Re: KBUR Proposed SID Procedures OROSZ THREE and SLAPP THREE

The City of Los Angeles ("City") provides these comments in response to the Federal Aviation Administration's ("FAA") request for comments on the above-referenced proposed OROSZ THREE and SLAPP THREE RNAV procedures.

Historic Resources within 5 Miles of JAYTE

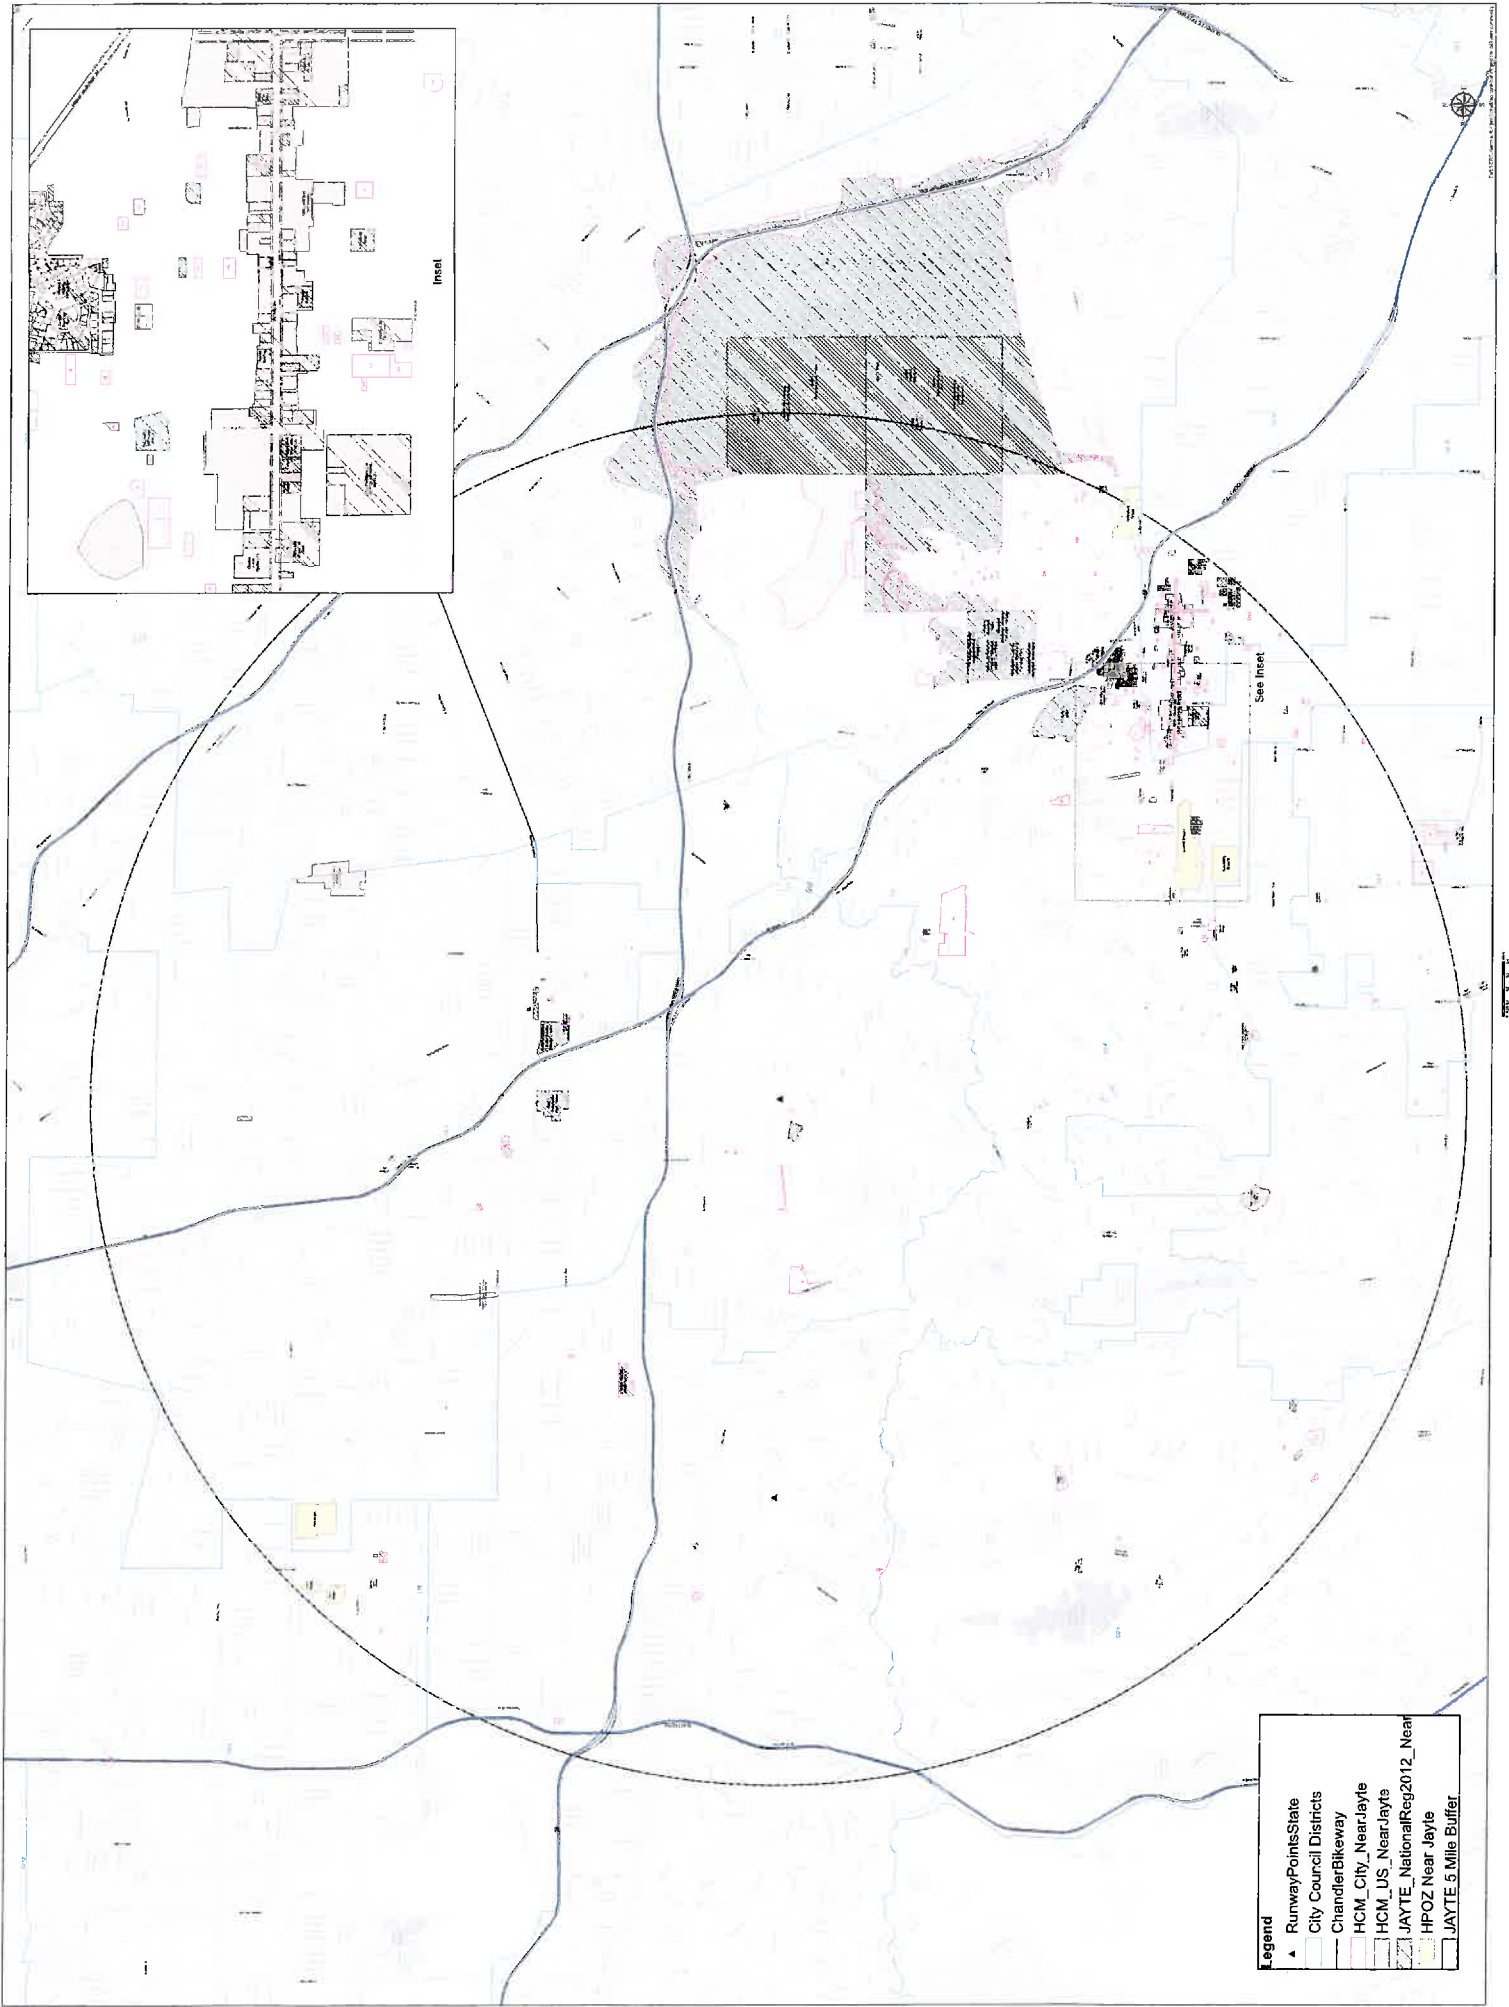
1. An impact on cultural resources protected under the National Historic Preservation Act, including the historic properties located under or near the proposed routes identified in Attachment 1 to these comments. See FAA Order 1050.1F ¶ 5-2(b)(1).
